महाराष्ट्र जीवन प्राधिकरण

जाक्र :- मु.अ(पुणे)/चिशा/दरसुची २०२१-२२/शुध्दीपत्रक/१७५९ दि.०९ ऑक्टोबर २०२१

शुध्दीपत्रक क्र ३

विषय:- मजीप्राच्या सन २०२१-२२ च्या दरसुची मध्ये १) Supply and installation of prefabricated ground water storage bolted tanks आणि २) Integrated Wetland Technology Based Sewage Treatment Plant चा समावेश करण्याबाबत.

8. Block Diagram Integrated Wetland Technology (IWT)

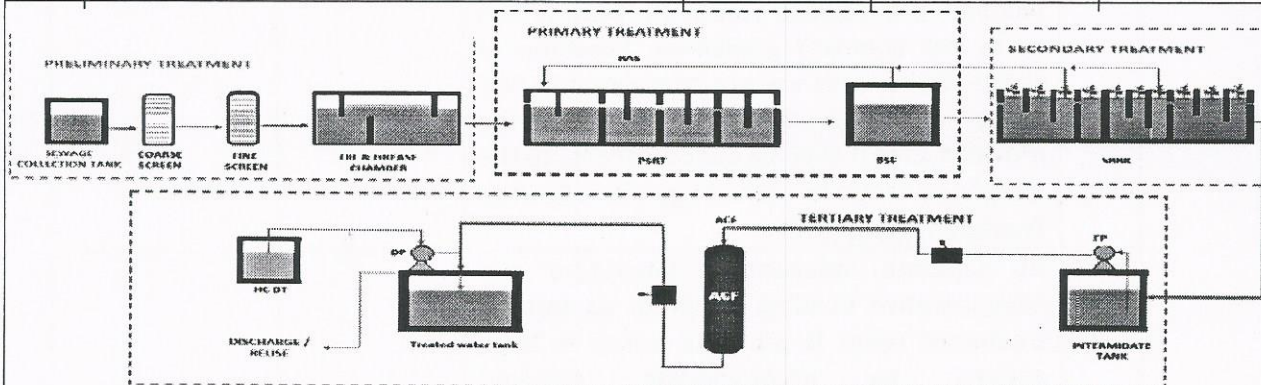
3. Primary Treatment Tank Designing, providing, constructing and hydraulic testing in RCC (M-300) watertight underground primary treatment tank (including PSRT, SABR, BSF). Designs as per the drawings given by IWT technology provider. Design will consider the average flow, the 2 Dry Weather Flow (DWF) and the peak flow. Tank will be covered and PVC vent pipes having sand and activated carbon (as per details and design provided by technology provider) will be installed to prevent odour. 0.5% of horizontal slope is provided in the tank for the collection of sludge. Minimum free board of 0.3m is provided. It includes providing all necessary items such as gravel media, piping, valves, joints, launder, baffling, etc. as shown in drawings and additional items will be as directed by Engineering in Charge.	1 Nos.

4. Static Bed Biofilm Reactor (SBBR) Designing, providing, constructing and hydraulic testing in RCC (M-300) watertight underground secondary treatment tanks (SBBR). 0.5% of horizontal slope is provided in the tank for the collection and recirculation of sludge. Design and drawings given by IWT technology provider. Design will consider the average flow, the 2 Dry Weather Flow (DWF) and the peak flow. Wetland plants will be planted on gravel media (as per designed by IWT technology provider). In the open recirculation sections a combination of Bottom screen, MS mesh, PVC sheet, and	1 Nos.

<u>6. Tertiary Treatment Unit</u> Designing, providing, installing and hydraulic testing of feed pump, activated carbon filter vessel with required sand and required activated carbon quantities, hypo dosing tank, dosing pump, necessary piping, pumps, joints, electrical cables, connections etc. complete. It also includes trial run of tertiary treatment unit. After dosing contact time of 30 min allows 99.99 % reduction of fecal coliform. Chlorine dosage will be as per standard requirement of 5-10 ppm. to match effluent quality as mentioned in table number "B". The Unit shall be as per approved design of technology provider.	1 Nos.		
	<u>7. Treated Water Outfalls</u> Designing, providing, constructing appropriate outfall sewer of RCC NP Class -III pipe to discharge treated effluent, untreated effluent from bypass chambers to the point shown on the drawing including necessary chambers for inspection and cleaning including excavation, dewatering, refilling, concrete, encasing / bedding concrete at the point shown on the drawing.	1 Nos.
